Addendum No. 2
December 10, 2021

Project: Harrisburg High School - 9th Grade Academy
Sioux Falls, South Dakota
Architecture Incorporated Project #2904

Architect: Architecture Incorporated

8.20-1BA

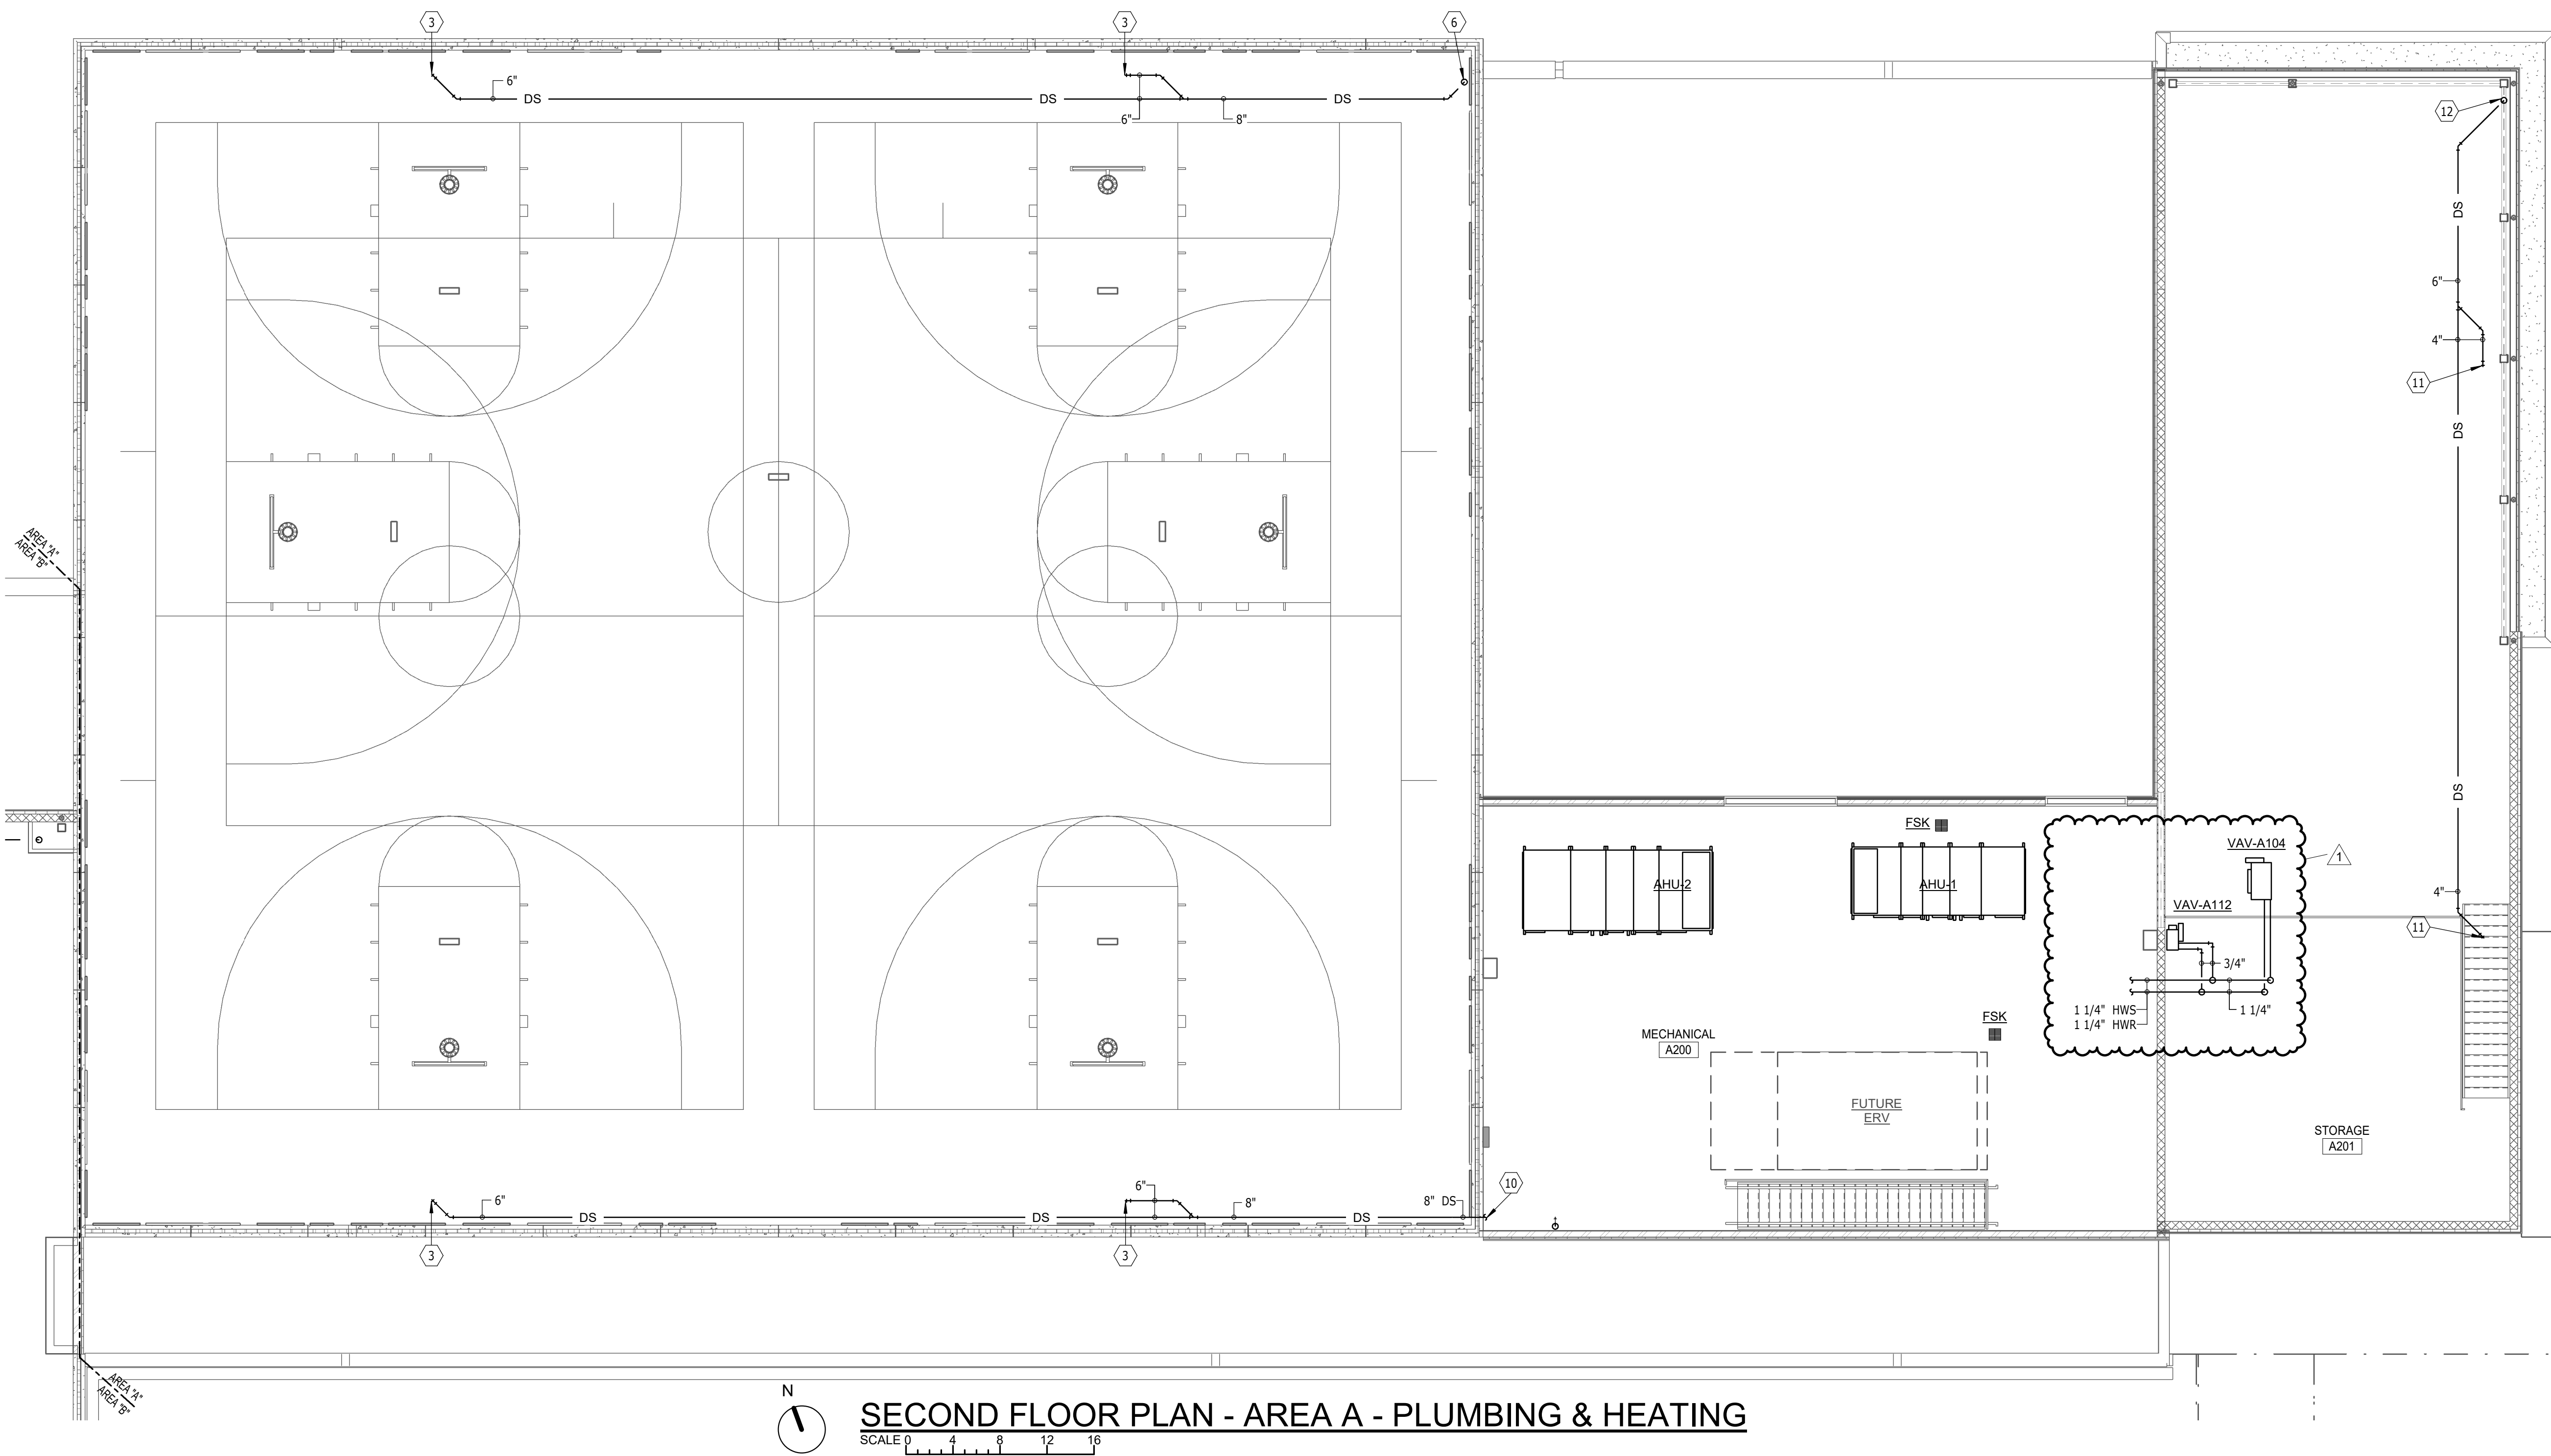
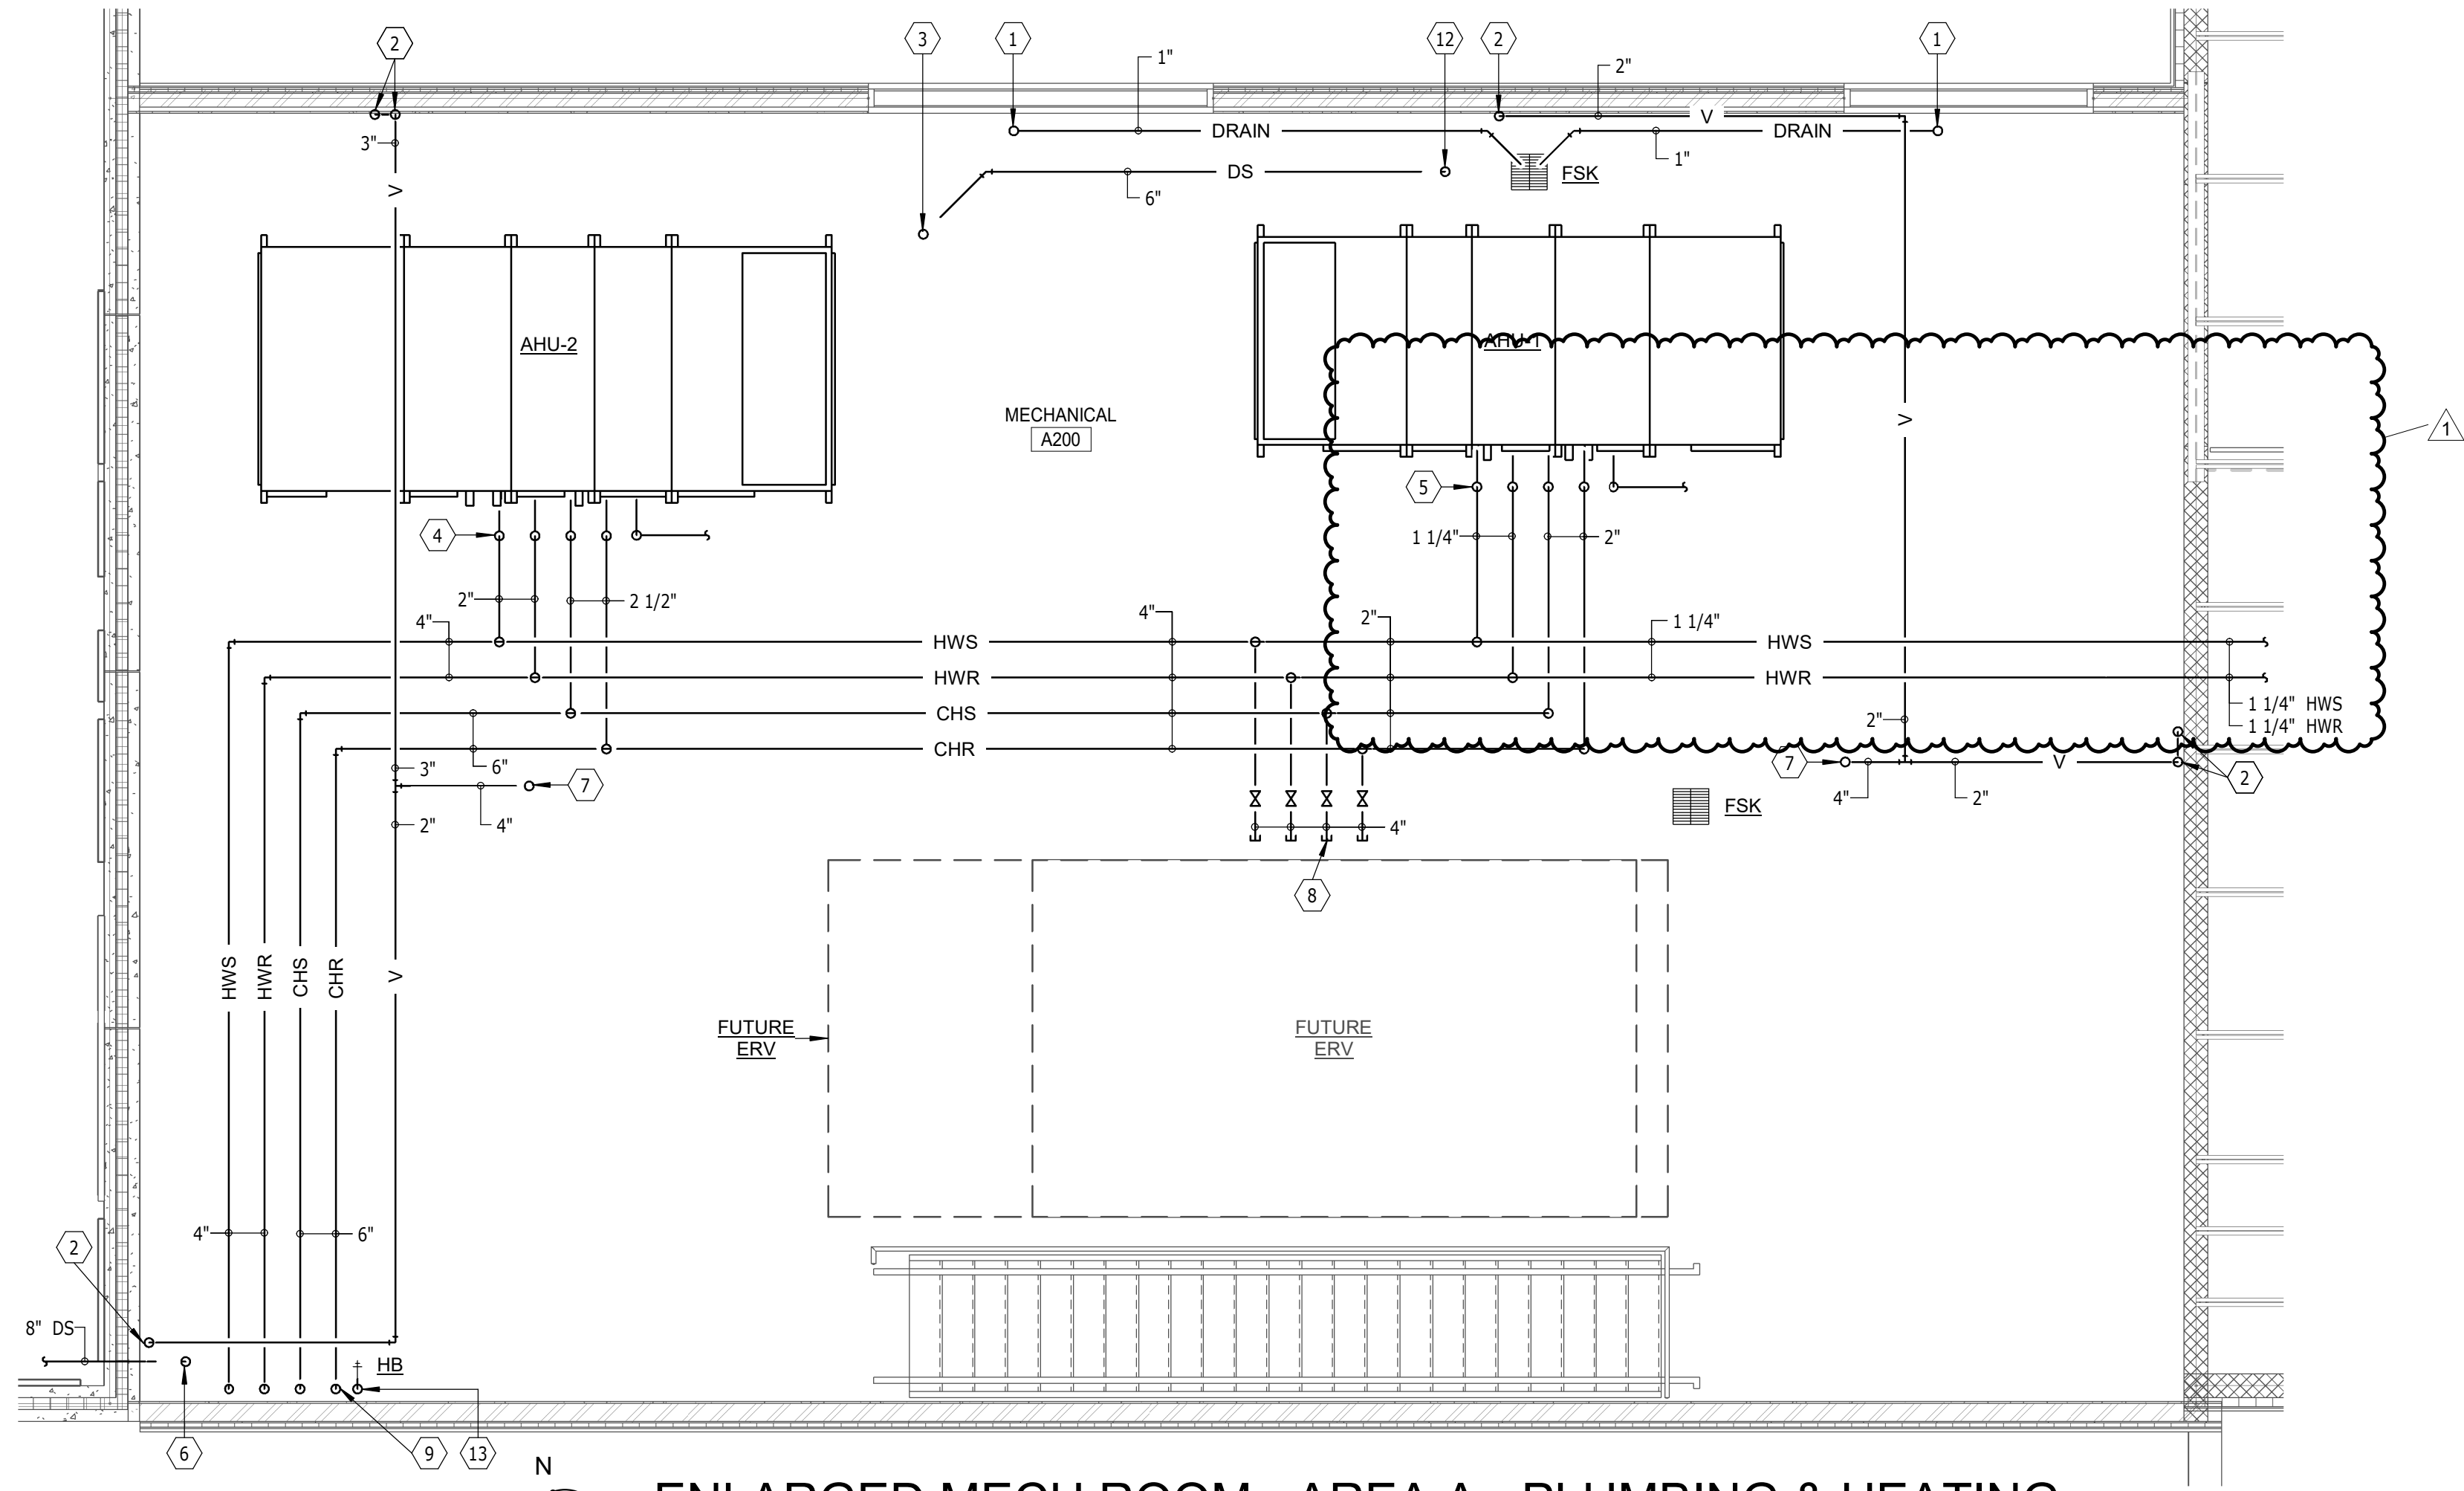
- a) STOR./REC./MECH./ELEC. ROOM B130: Add 1 ½” drain with shutoff valve on cooling tower piping. Refer to revised drawing sheet 8.20-1BA, ADDM M2, dated 12/10/21.

8.20-2A

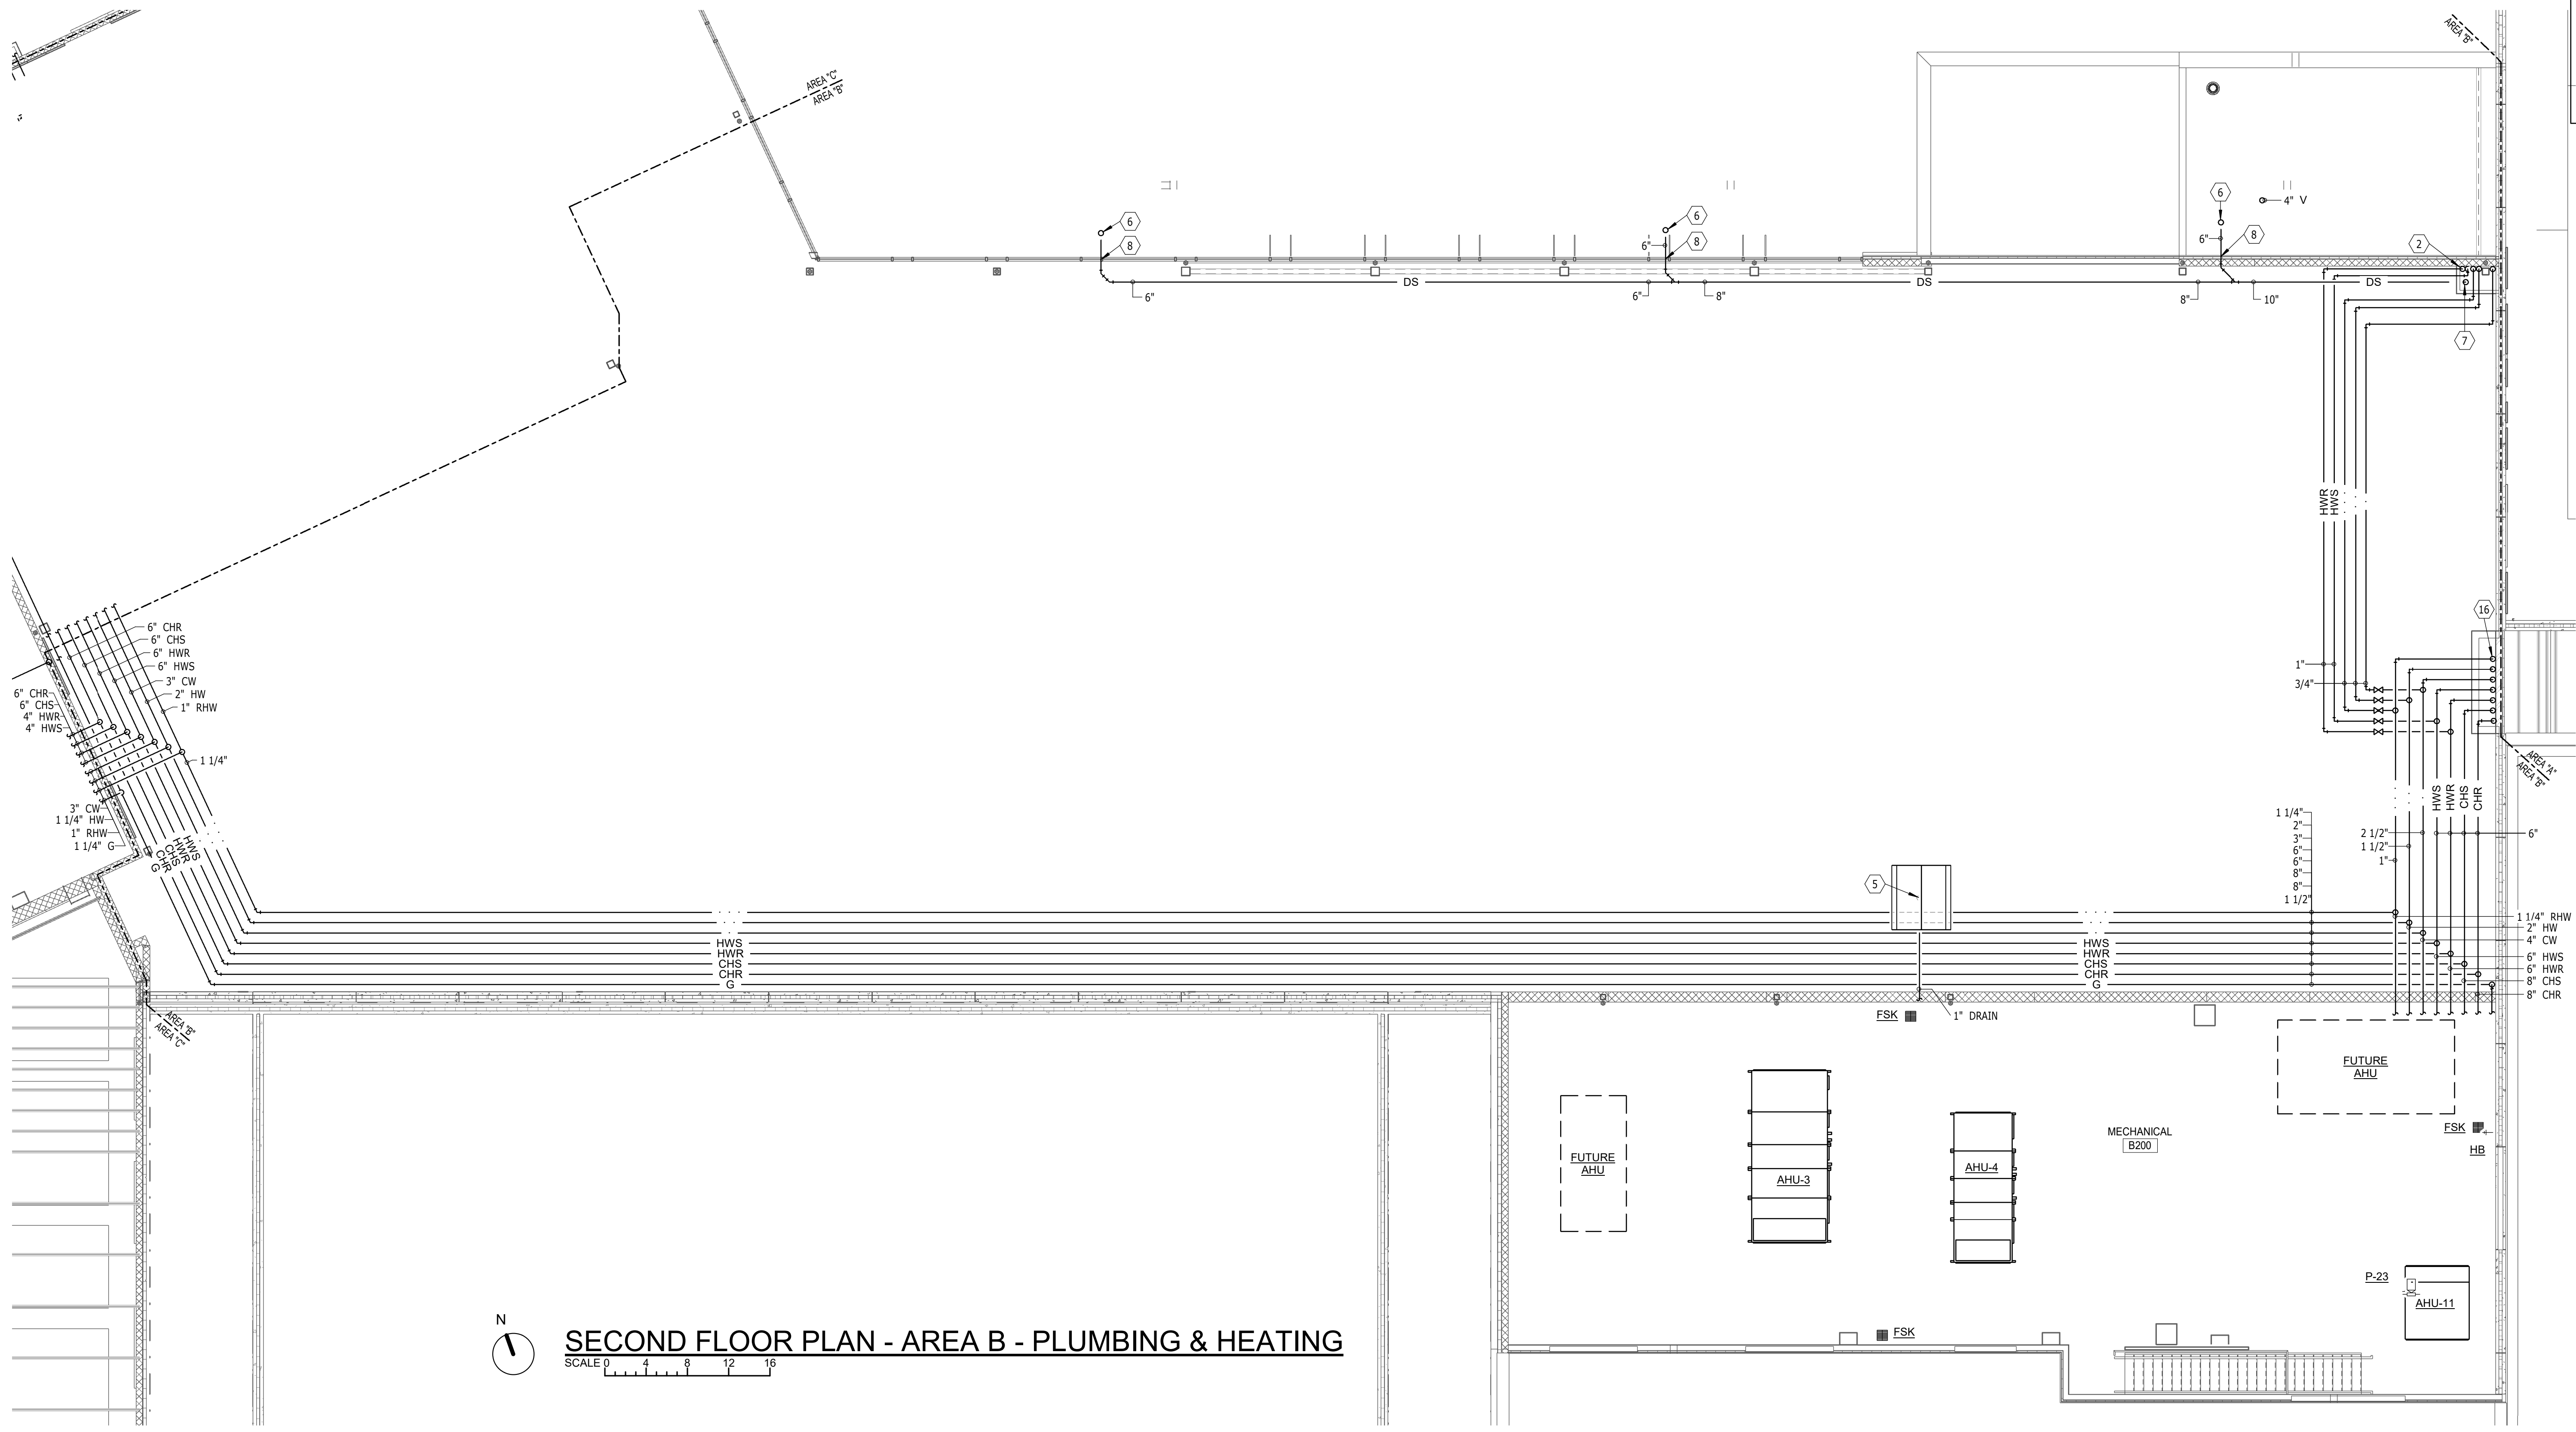
- a) MECHANICAL ROOM A200 & STORAGE ROOM A201: Add VAV-A104 & VAV-A112 & associated piping. Refer to revised drawing sheet 8.20-2A, ADDM M2, dated 12/10/21.
